MILITARY SPECIFICATION

MICROCIRCUIT, DIGITAL, CMOS (FINAL LOGIC)

This Amendment forms a part of Military Specification MIL-M-63321A(AR) dated 8 April 1981, and is approved for use within the US Army Armament Munition and Chemical Command and is available for use by all the Departments and Agencies of the Department of Defense.

FIGURE 11. Burn-in and steady state of life test circuit.

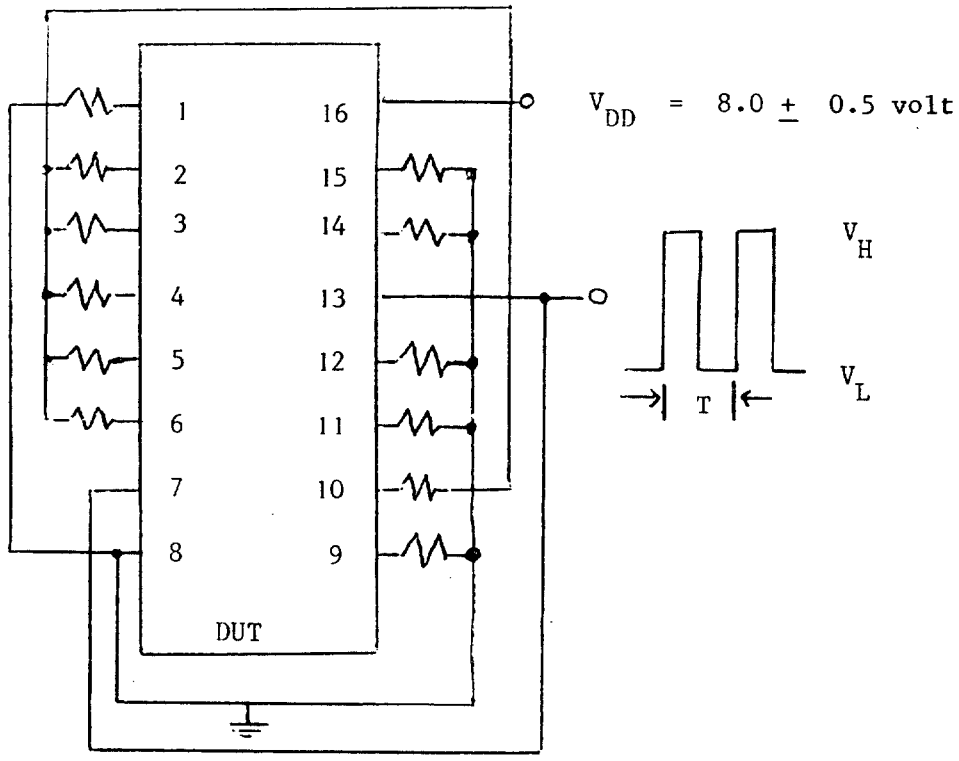
FIGURE 11: Delete present and substitute revised FIGURE 11 included to this amendment.

V_H = 8.0 - .5 volts

V_L = 0.5 ± 0.15 volts

T = 40 ± 4μs period, 50% duty factor.

All R(s) = 51K ohms max.
